# UNITED STATES PATENT AND TRADEMARK OFFICE

APPLICATION NO.	FILING DATE	FIRST NAMED INVENTOR	ATTORNEY DOCKET NO.	CONFIRMATION NO.
09/882,703	06/14/2001	Heinrich Foltz		9610

<b>Office Action Summary</b>	<b>Application No.</b> 09/882,703	<b>Applicant(s)</b> FOLTZ ET AL.	
	<b>Examiner</b> CHUC TRAN	<b>Art Unit</b> 2821

## DETAILED ACTION

**FIG. 15**

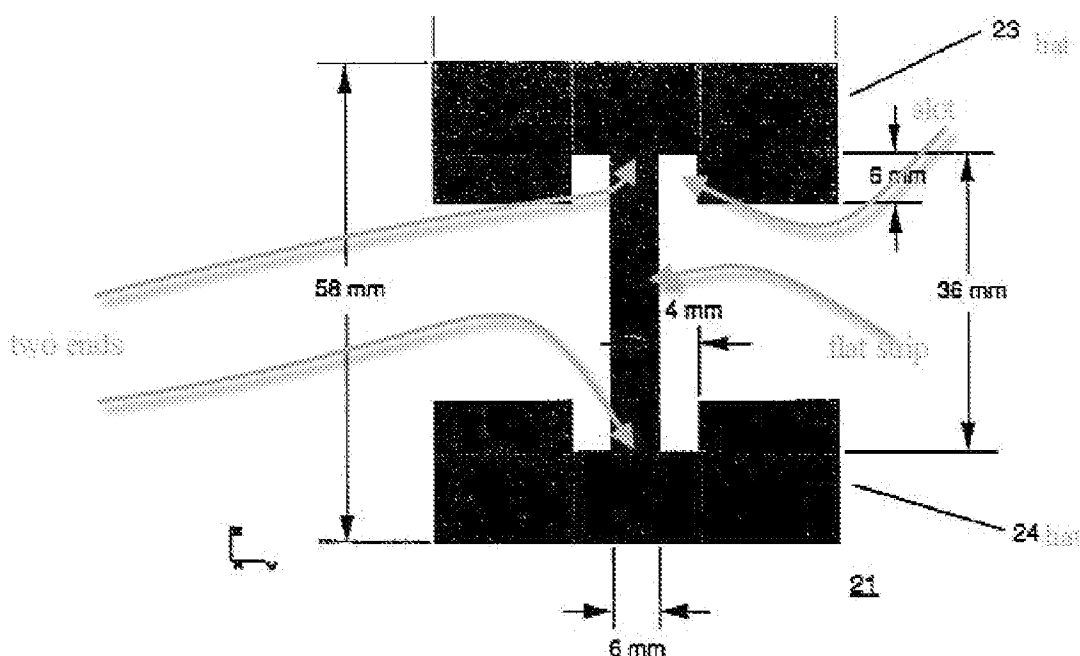
Regarding claim 3, Johnston et al disclose a parasitic reduce size printed dipole antenna element in Fig. 9-10 and 15, comprising: a dielectric substrate (8) (Fig. 9B, Col. 5, Line 43); two

conducting patches (sheet) (23, 24) one at each end of the dipole (Fig. 15, Col. 6, Line 11), a conducting strip (strip) (Col. 6, Line 13) narrower than the patches connected to said conducting patches (sheet) (23, 24) (See Fig. 15, below), forming a radiating part of the dipole element (Col. 3, Line 30), and a slot cut into said conducting patch (23, 24) (See Fig. 15, below).

length of said conductor (Fig. 3). However, Quade is silent on a limitation of said linear conductor having a first end and a second end. Johnston et al reference teaches in Fig. 15, said linear conductor (flat strip) having a first end and a second end (See Fig. 15 above). It would have obvious to incorporate the Johnston's teaching into the Quade's teaching for reducing the input impedance in order to improve the antenna elements.

conductor having a first end and a second end. Johnston et al reference teaches in Fig. 15, said linear conductor (flat strip) having a first end and a second end (See Fig. 15 above). It would have obvious to incorporate the Johnston's teaching into the Quade's teaching for reducing the input impedance in order to improve the antenna elements.

**FIG. 20**

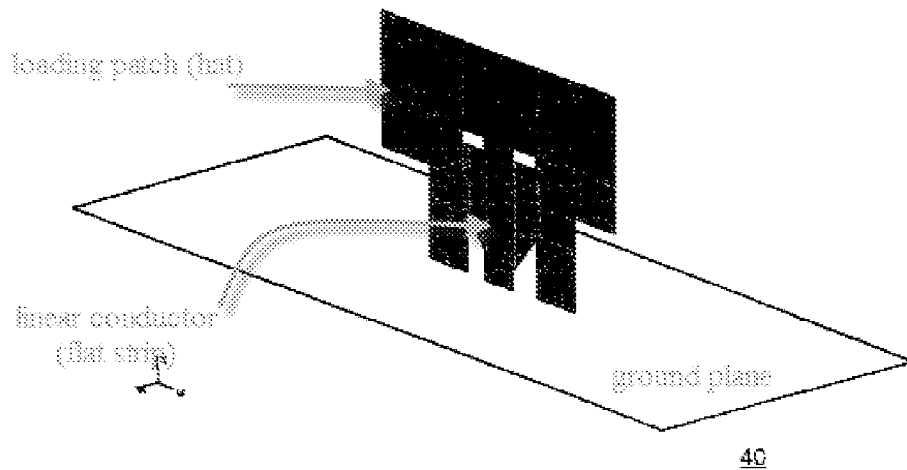
Regarding claim 4, Johnston et al disclose that one half of the dipole antenna (21) mounted on a ground plane (Fig. 20, below, Col. 6, Line 45-49).

Regarding claim 23, Johnston et al disclose that said ground plane is a conducting ground plane (Johnston, Col. 6, Line 49).
